DATE	NAME
DRAWN BY		
CHECKED BY		
APPROVED BY		
APPROVED BY		
PROJECT UAE PLANT

TITLE EQUIPMENT LAYOUT 1ST FLOOR (EL +0.00)	
DWG NO. —	REV.
SCALE	WEIGHT
SHEET	OF

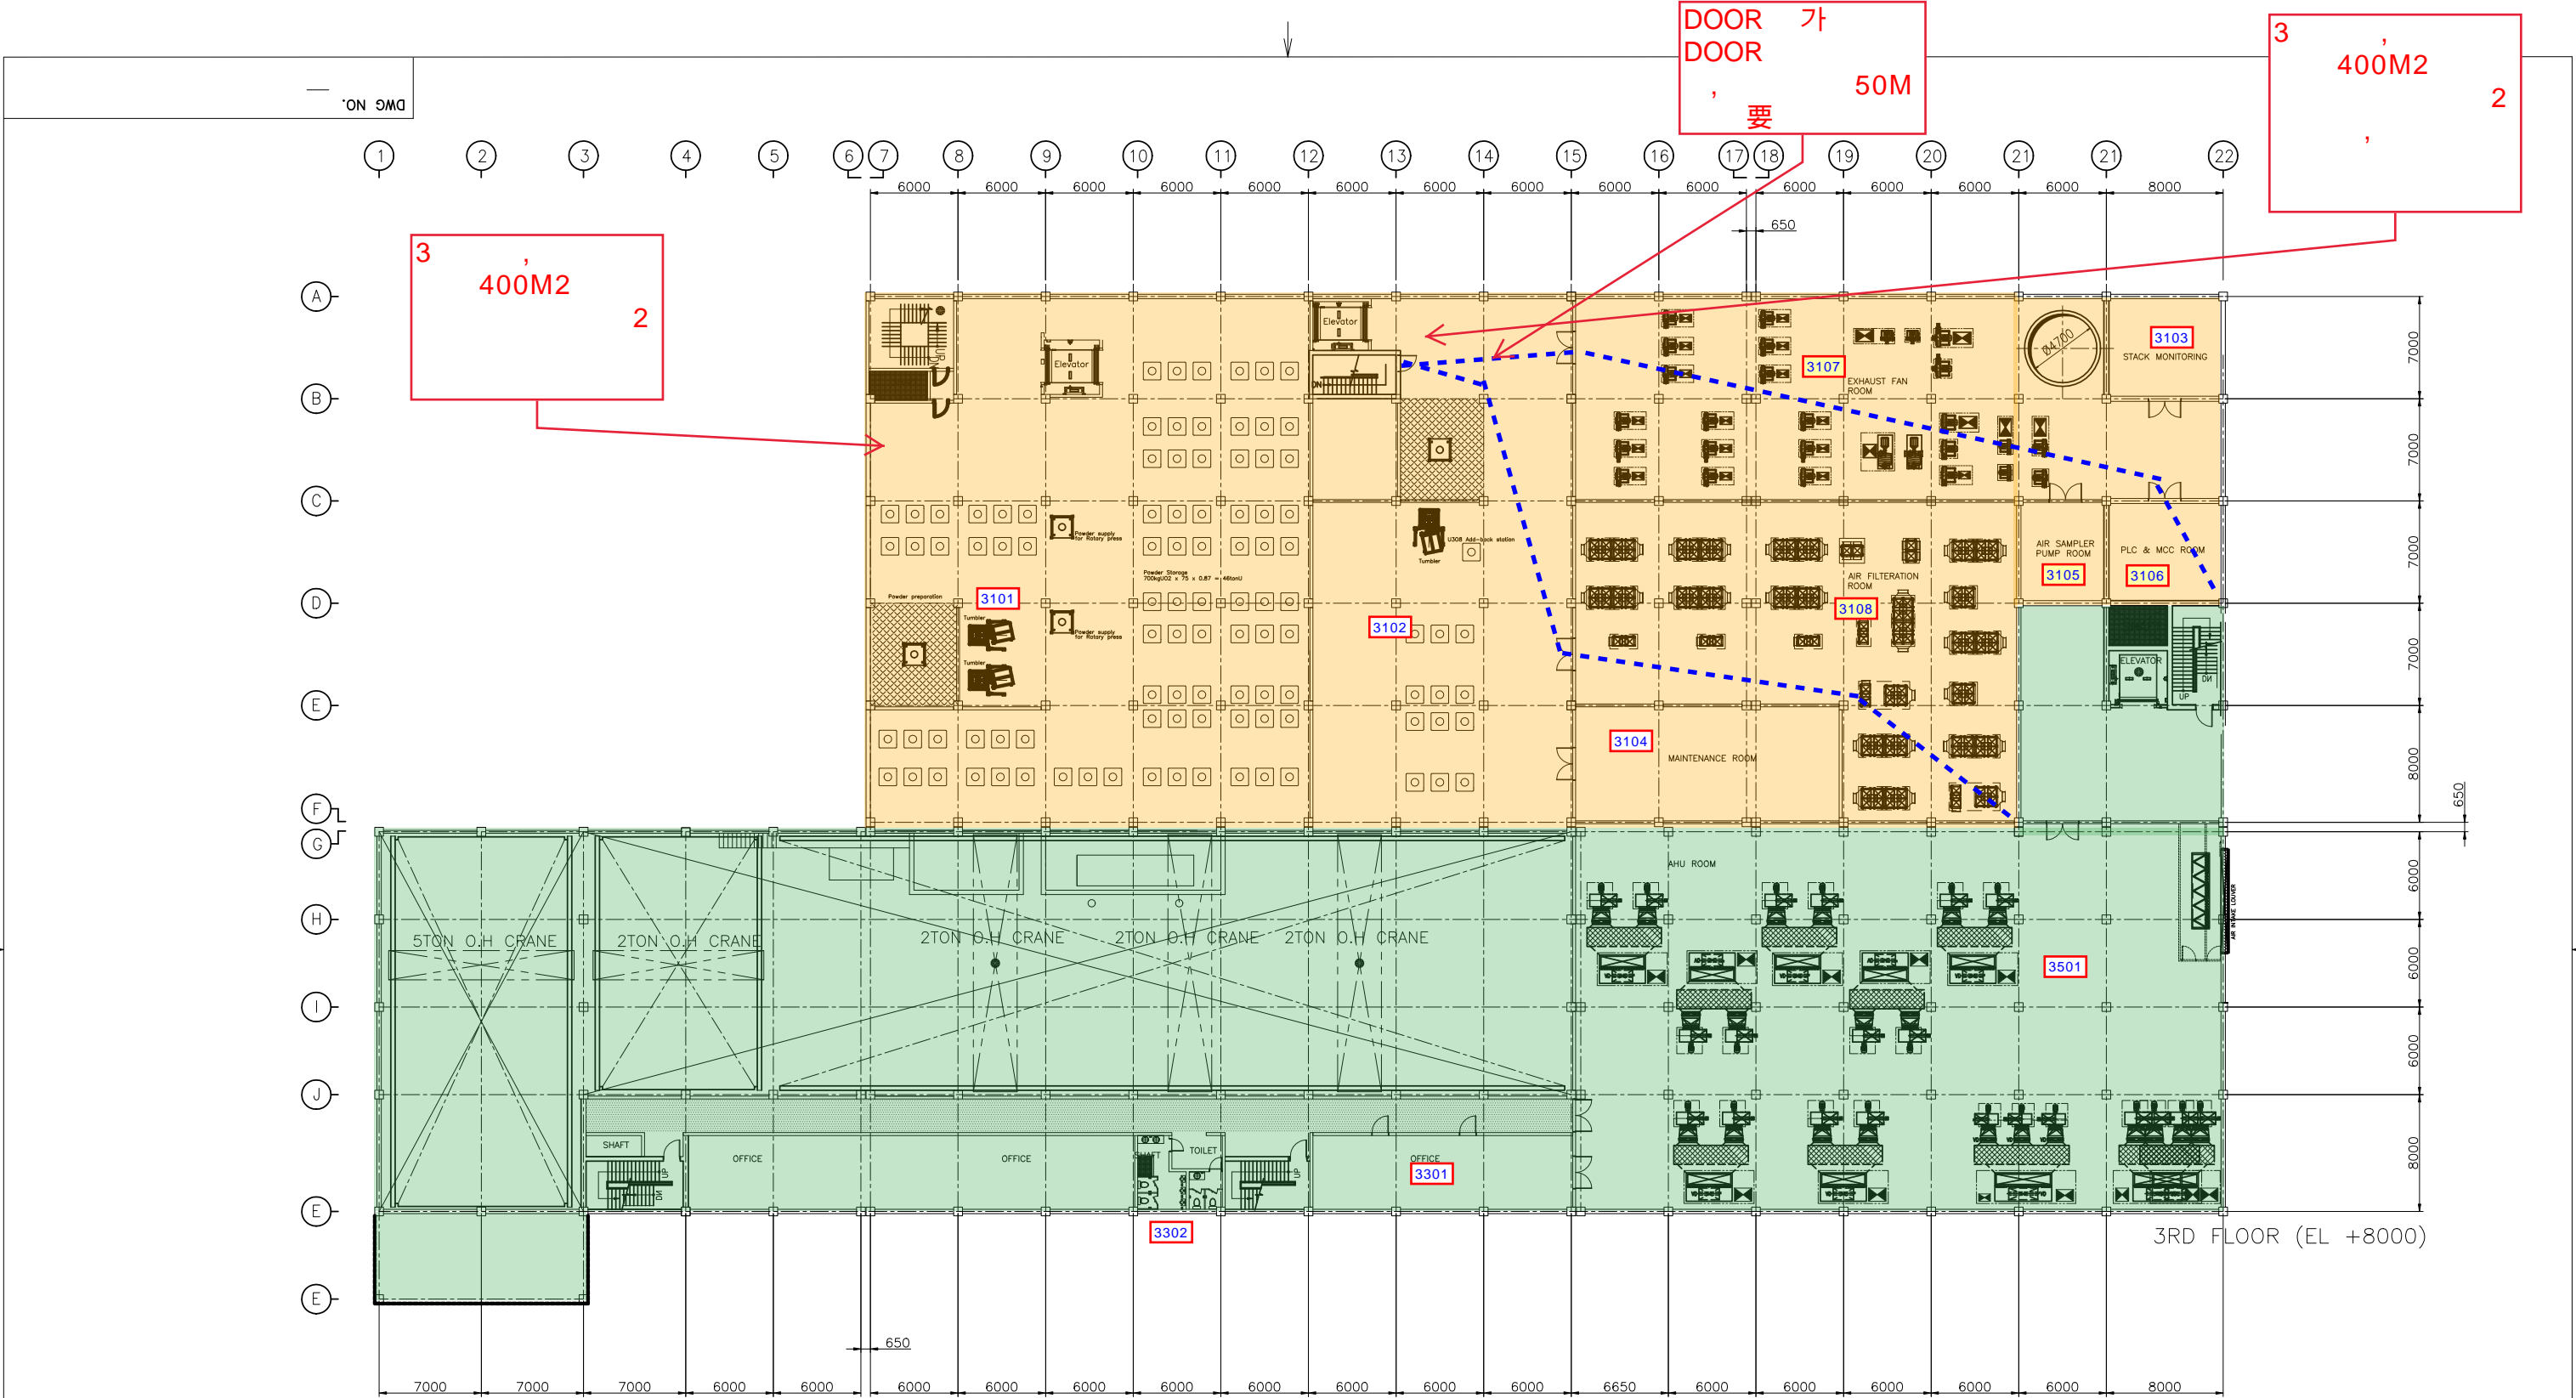
1. 재변환공정상기 확장은 고려시 고처리율을 얻은것으로 확인요망
2. Pellet 저장실이 현역로 3공장의 1층에 설치되는 우라늄 저장실인지 확인요망
확장설비가 자동화 개념이 적용되었는지 확인요망
3. Cleaner Room이 Shower실과 같은 개념인지 확인요망
(우측 출입구 지역)
4. UO2 분말용기 저장구역
저장용량 : 75계 용기 46ton-UO2-산전 근거 확인요망

Door 추가

관리구역 출입
전 화장실 출입
이 가능하도록
서측으로 이동
